FW: ES-20-670 Eagle Academy Public Charter School - Request for Plans

1. Item 3 of the letter states: "Install wicks connecting to the underdrain 5 feet apart for the length of the bioretention between the most eastern overflow and most western overflow". Do you have a standard detail for these wicks that would meet the requirements of the Department and Energy and Environment?

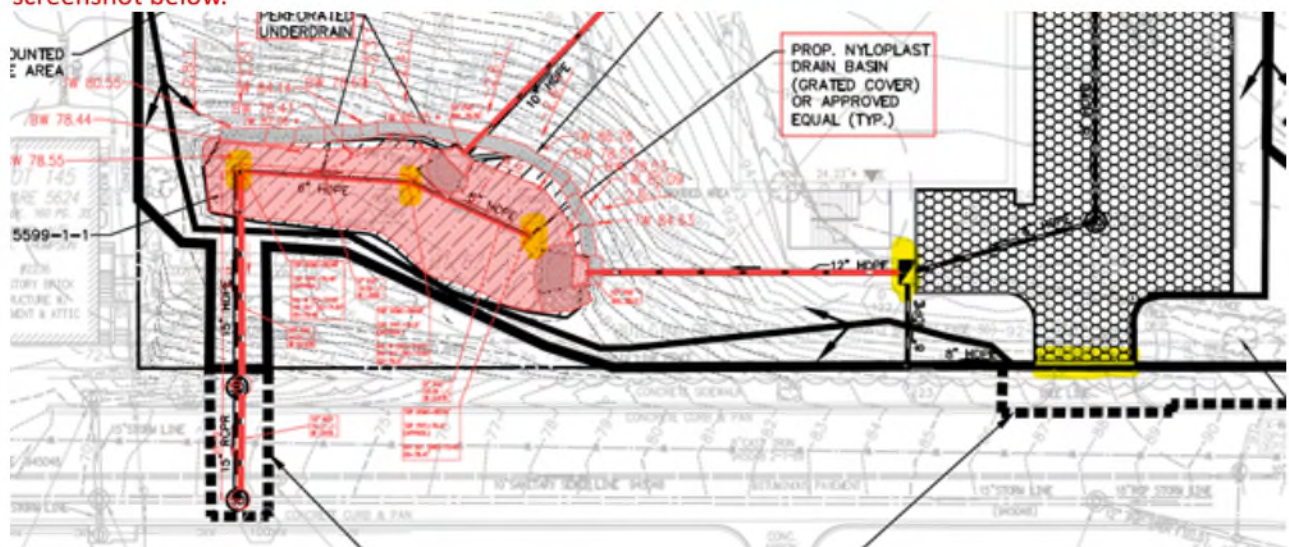
2. Could you please specify exactly which inlets are to be vacuum cleaned as mentioned in item 6?

I attempted to highlight the inlets of interest below. There are 5 inlets/overflows highlighted in the screenshot below.
